# Access Compliance Report

## Public Rights-of-Way

### (Pedestrian Signals)

Intersection ID: N/A	Main Street:	Cross Street: N/A	Location: N/A
ADA ID: 4AA6FFEADF23	Signal Type: Two Push Buttons-Non APS	Overall Compliance: No	Severity Score: BTN 1:N/A BTN 2: N/A No BTN: N/A
Codes/Mitigation Info/Possible Solution		Field Measurements/Component Compliance

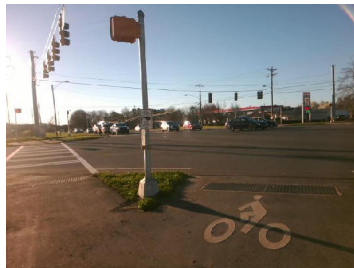
Surveyor Notes: second button headed SW IS FOR BIKE ONLY

PROW/ADA: TMUTCD 4e.08, R404.2, R404.3, R404.7.2, R406.2, R404.7.3, R406, R403.4

Possible Solutions: Replace Signal Push Button With APS Button on New Post. Remove & Relocate Sign.
